*COMMENTS ON ANY FURTHER
INFORMATION / SUBMISSIONS
RECEIVED BY DEADLINE 5*

CowfoldvRampion and Cowfold Residents
CowfoldvRampion@gmail.com

Version 2 – August 2024

Table 6-3 HGV access routes:

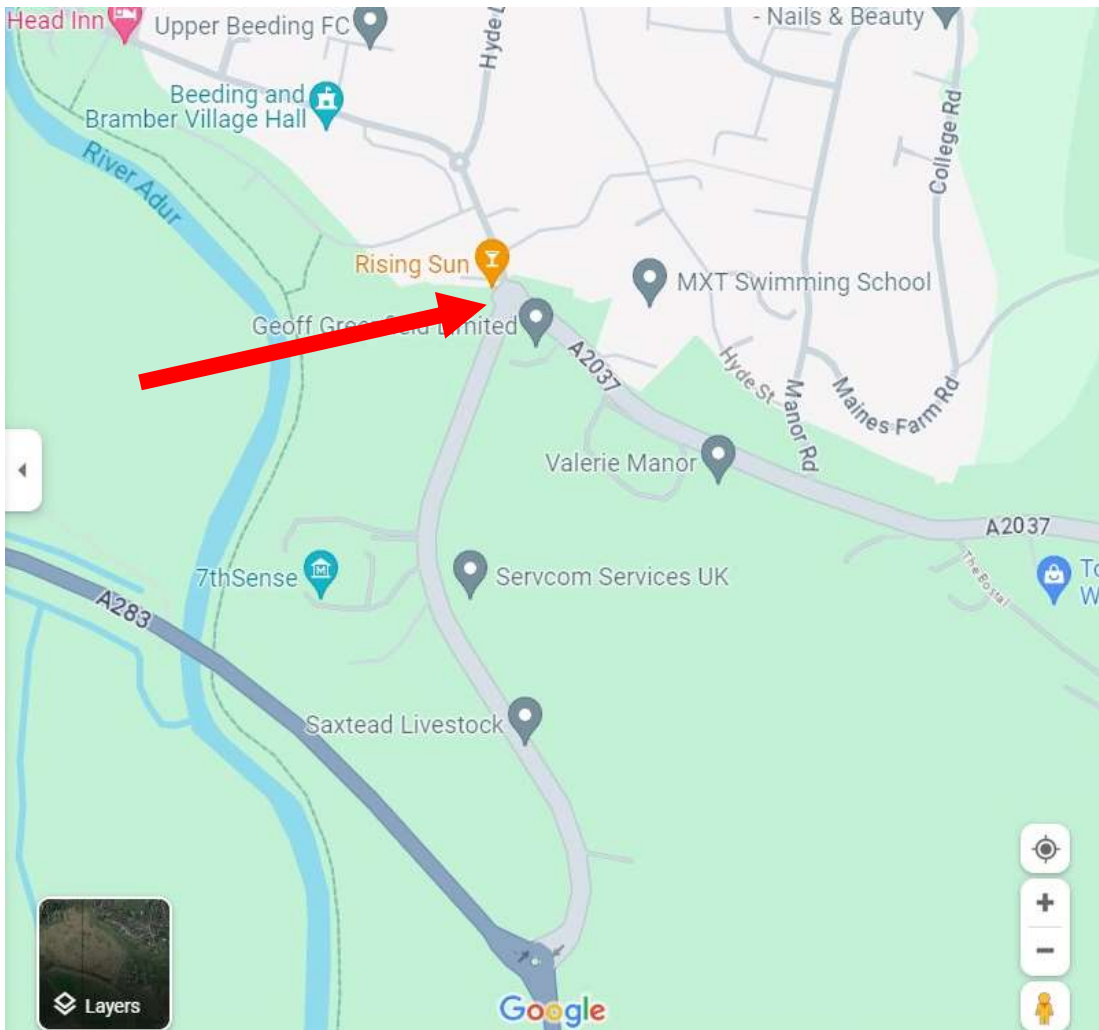
Access routes to A56 and A57 now also include the southern route through Henfield, but are still also showing the route through Cowfold. There is still no diagrammatic proof that can these larger HGVs can navigate the sharp bend in the A2037(see map below), or Henfield high street

Table 6-7 Total two-way construction movements by access:

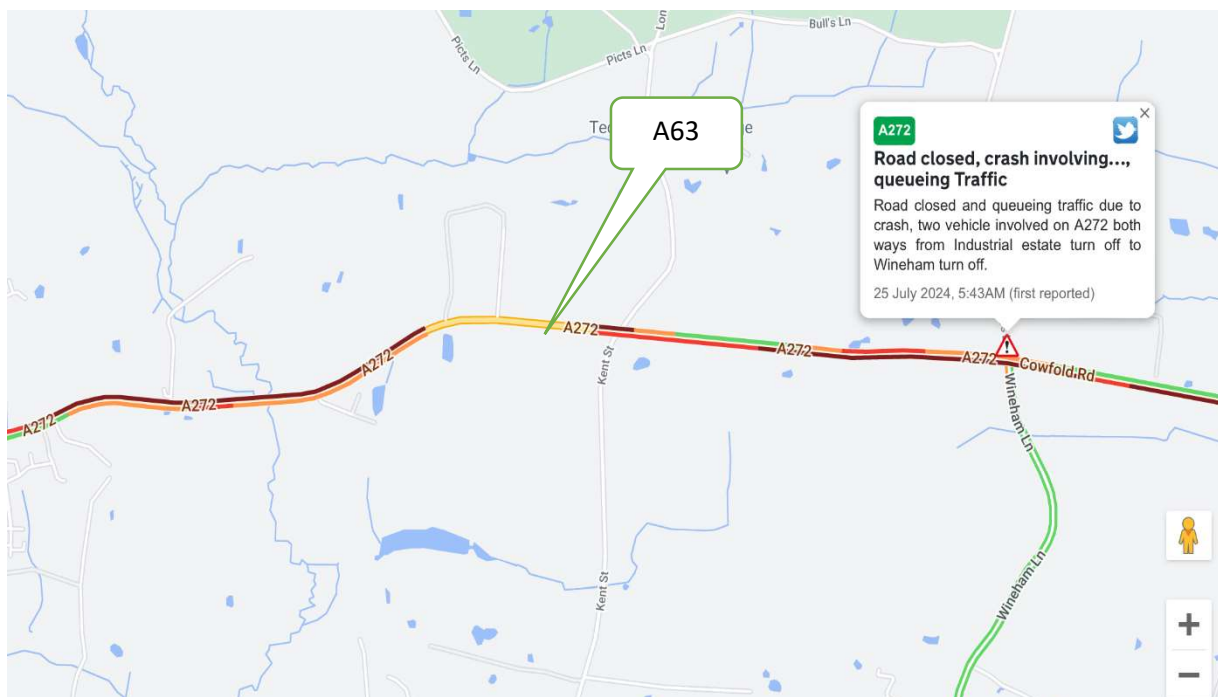
Every movement involves a turn on or off the A272, which generated queues and congestion. Across the access points which generate these turnings close together ie Kent Street (A61 and A64), A63 and A62, there will be a total of 69,888 LGV movements and 19,428 HGV movements. This will cause serious congestion on the A272, particularly as many of the LGV movements will be together at either end of the day. The HGV movements are a very different picture from figure of 8040 they used for the A272 throughout the consultation

The potential to back up into the Cowfold AQMA is very great. This has not been factored in to the AQ calculations or any feasible plan about how the congestion on the main road can actually be managed for four years.

Temporary speed limit:

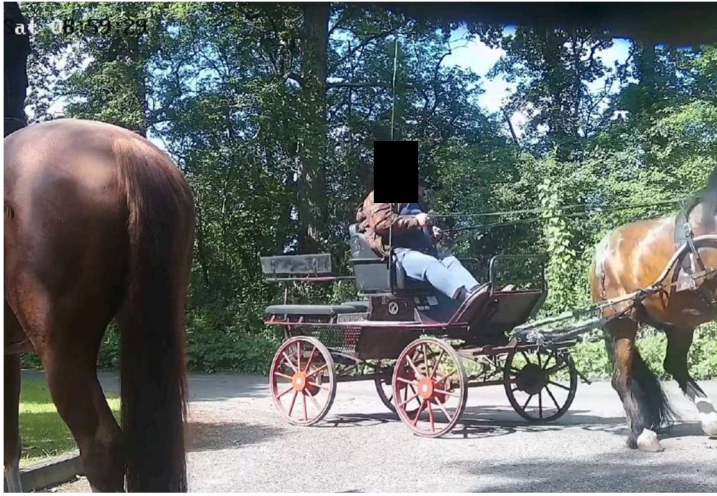
The temporary speed limit on the A272 will not help their vehicles to get out onto the A272 as the constant stream of traffic from both directions make this very difficult; there are no gaps.

Passing place drawing showing actual width and length needed as per Rampion dimensions – not vectors but areas which will be destroyed, leading to increased vegetation loss along the west of Kent Street and views into the substation site

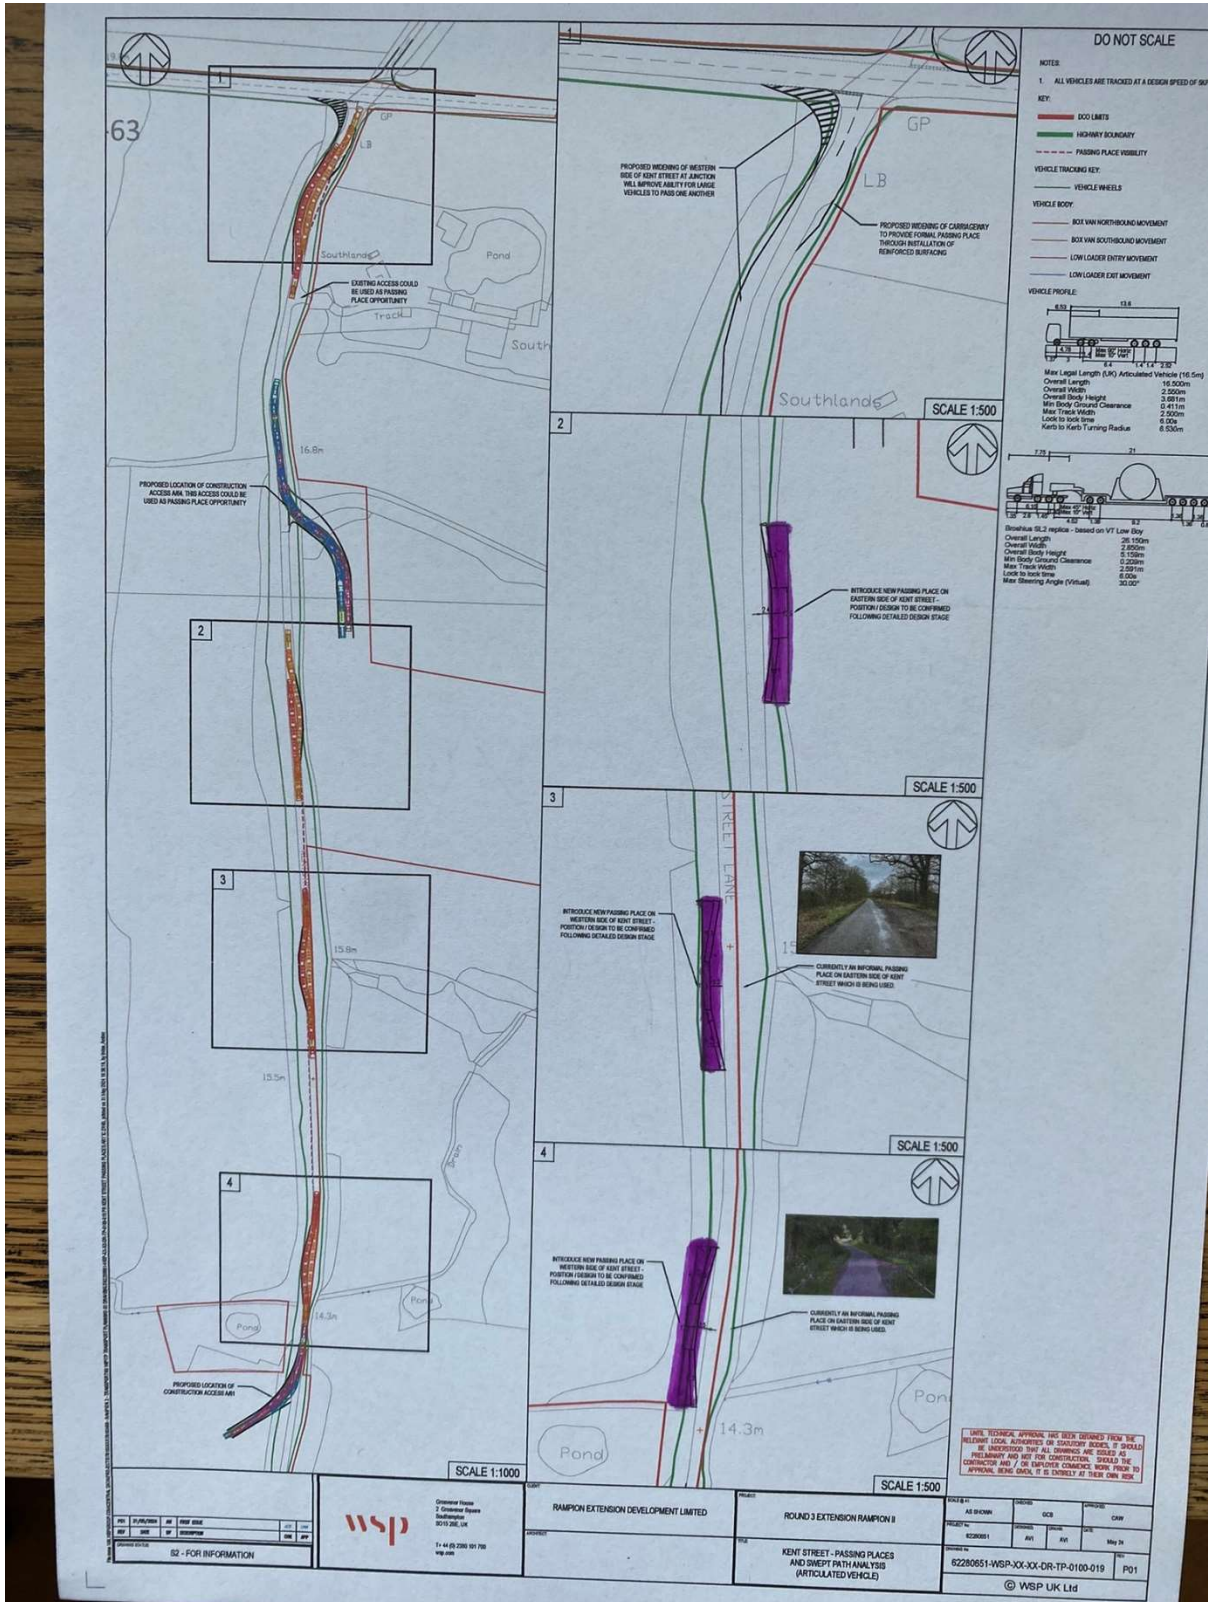
The latest plans in drawing “Kent Street – Passing Places and Swept Path Analysis”, only shows the passing places in vector form. It does not represent what a width of 3m passing place and 16.2m plus 12.5m plus 16.2m = 44.9m long. The lane is only 2.9m wide, the vector showing 2.5m is from the middle of the road. This would not enable 2 x construction lorries to pass, or a lorry and other Kent Street traffic. The passing place would need to double the current width of the lane – even more as lorries would need to pull in their wing mirrors if only 2.6m x 2 in widths.

The plans conceal the truth about the amount of vegetation removal by not clearly demonstrating the width of the passing places or road, or the HGVs.

REP5-069 outline CTMP tracked contains more detail on the Tracsis surveys:

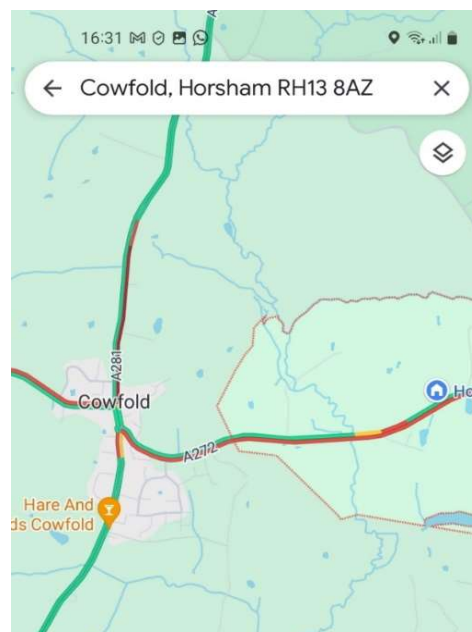
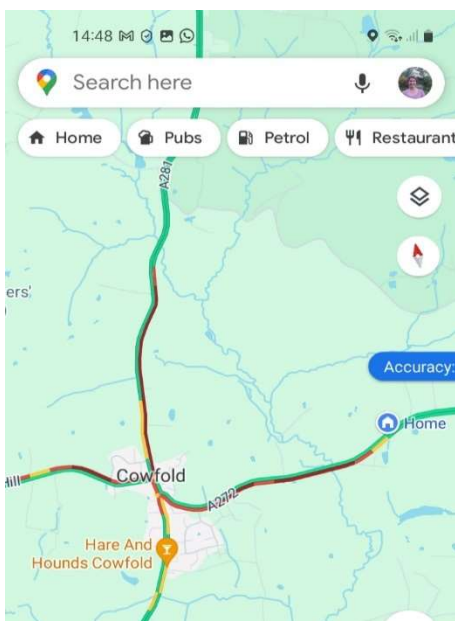
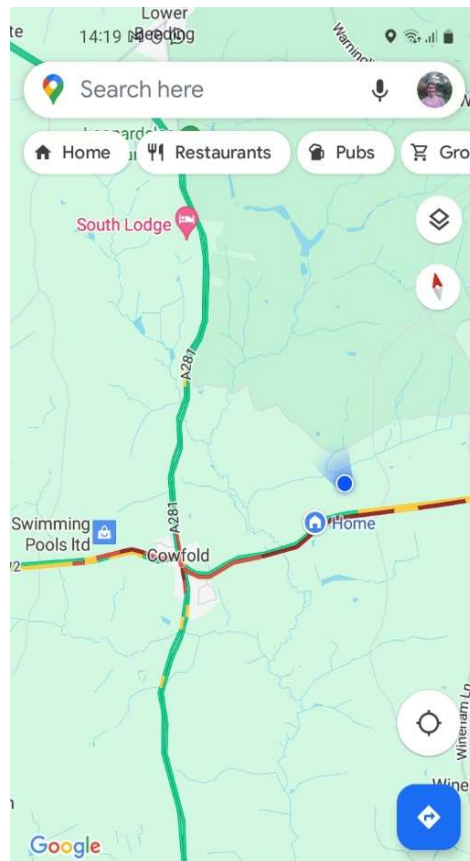
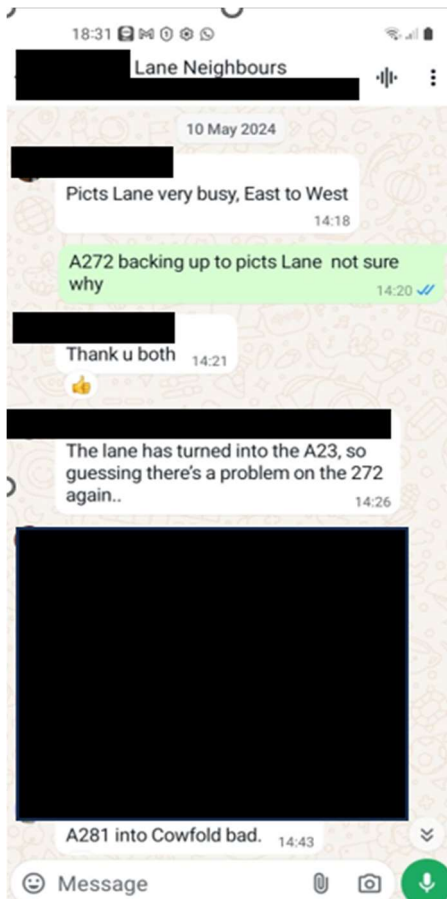
3.2.4 "Traffic data collected by Streetwise Tracsis on Kent Street is shown in Table 3-1 below. This was collected via ATC survey located approximately 1km 850m south on Kent Street from the A272 junction. AM and PM peak hours summarised in Table 3-1 show the busiest recorded hour between 8-9am and 3-4pm"

In fact, the 'survey results' in table 3-1 shows a **highly selective** part of the data from the Tracsis survey, carried out for Rampion between 8th -14th May 2024. We are simply presented with the some of the average figures for the week. **No data is given for HGVs at all, no other times are shown, so we have to take the applicant's word for the figures at other times, even though the Enso survey showed the middle of the day as the busiest, and we are given no breakdown of the vehicle classifications at all.**
